LaSalle Causeway Concrete Repairs
EQ754-2221279/A

AMENDMENT No.4, dated 2021-10-25

QUESTIONS AND ANSWERS

Figure 3: CB05 - Ceiling - Exposed Rebar (2021.03.11).

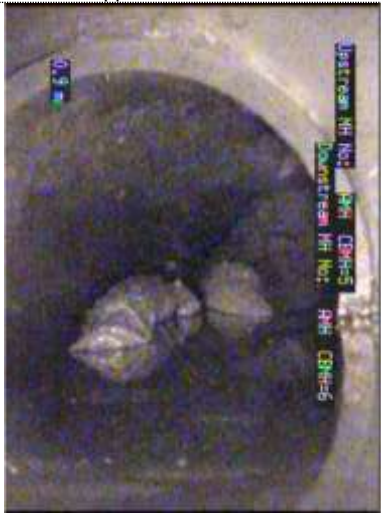
- The ceiling of CB05 has some exposed reinforcing steel, see Figure 3. From the video it appeared that there was little loss of section in the bars as they appeared to be of uniform width with little or no necking or staining. The fact that the concrete is missing is an indication that some rusting has occurred or that concrete was poorly consolidated around the bars. The bars were originally #4 bars. Poorly consolidated concrete is present in the opening around the catch basin grate, but by contrast the concrete surrounding the beam is well consolidated. The catch basin ceiling spans in the direction where the bars for the most part are still partially embedded, and the spalled area is adjacent to the steel beam.

- The overall condition of CB05, while not perfect, based on the visual inspection likely has little loss of capacity. A protective coating could be added to the bars, but any protective coating or polymer modified concrete patching material would likely trap water and could accelerate the deterioration of the original concrete and would have to be considered carefully if other work proceeds. Based on this review while the catch basin could just remain in service if someone is entering the catch basin the reinforcing loss of section should be verified and physically measured to confirm the observations.
